APPROVED MINUTES OF THE MEETING

October 1, 2009

October 1, 2009	Project:	Fire Station 9 - Fremont
	Phase:	Concept Design
	Last Reviewed:	N/A
	Presenters:	Teresa Rodriguez, Fleets and Facilities Department Casey Huang, Mithun Doug Leigh, Mithun
	Attendees:	Christina Faine, FFD Craig Skipton, Mithun David Kunselman, FFD Dove Alberg, FFD Evanne Vaivadas, FFD Jason Huff, Office of Arts and Cultural Affairs Lindsay King, DPD Molly Douce, Fire Department Peter Reiquam, New Art Projects Company

The Design Commission thanked Teresa Rodriguez of SDOT and the design team from Mithun for their clear and concise presentation of the conceptual design for Fire Station 9 in Fremont. The Commission approves the concept design unanimously.

Site Plan

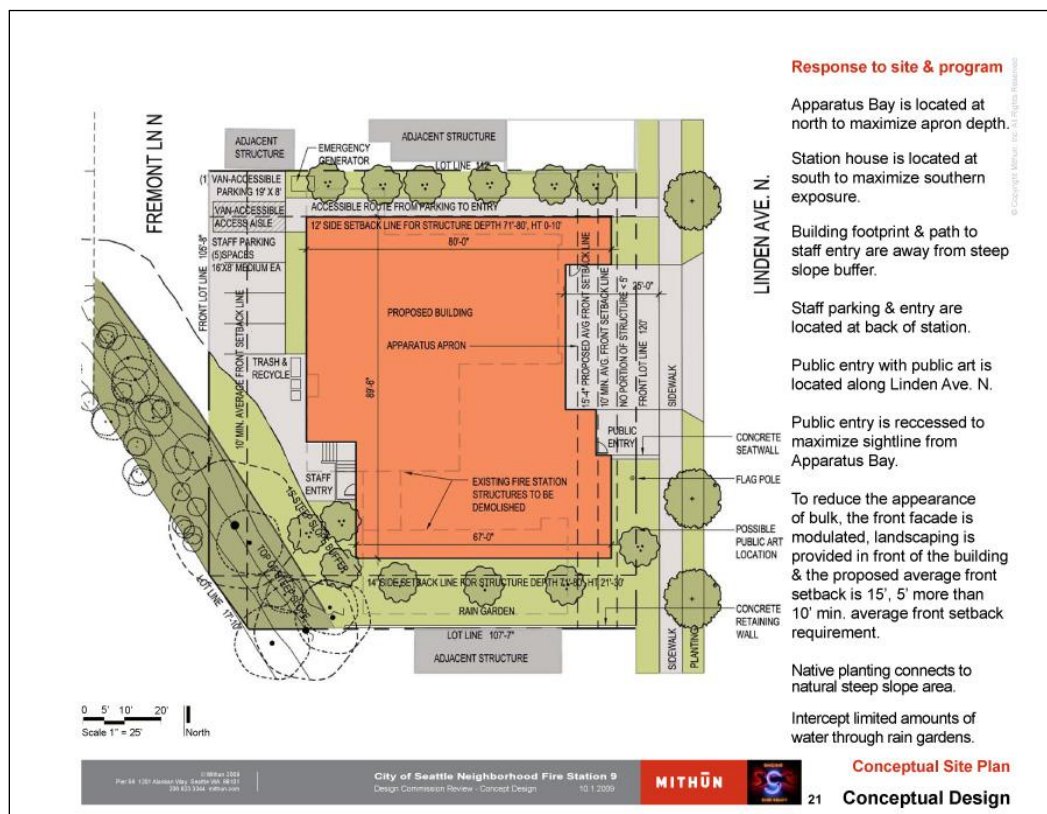
It is a really tight site. Did you try to swap out the site for another?

You might save the annex façade as a freestanding wall. That corner could become really interesting.

Think about a fire station with a porch. Where is the public face component?

Where is trash and recycling? Will it affect car access?

Consider the residents who are on the south in the design of the deck.

What about the edge between the buffer and the lot? There are 3 pinch points.

How much native planting will there be?

Your challenge is to work the proportion of the masses. What we've seen with previous fire stations is that the massing just gets fenestration applied. Relax on the rigidity of the massing.

The temptation is to break down the massing to match the houses. But you may have broken it down too much, more than the houses.

Can you include pervious paving?

Who uses the path on the north?

What about art integration? You have an interesting situation because of the existing art.

We would encourage a freer expression of the art. Don't feel enslaved by the "ever ready" logo.

I encourage you to think about how hardscape and softscape are integrated. They can intermingle.

When we see you again, it would be nice to see the materials.

Yes. Looked but the issue came down to response time and its close proximity to Aurora. The site is not small, but is constricted due to the lowrise zoning.

We studied it. It's in the wrong location. We couldn't fit the whole building program.

It's at the entry. There will be an opportunity with the grade change at the entry for seating walls and other opportunities.

Recycling occurs from the front. The firefighters roll the containers out to the curb.

We may use a solid wall rather than an open railing.

The design is just conceptual right now. We will study it more. We want to minimize the impervious area.

All the way around. A lot is required by LEED Silver. We want to tie it into the steep slope.

We're looking at it. We need to resolve the alley issue. Maybe the staff parking area and the public entrance could be pervious. We're limited by program, but we're looking.

It's an both an accessible route and for hauling garbage.

We haven't gotten that far yet. The "ever ready" logo is a jumping off point.

I don't feel enslaved. I feel inspired by it.
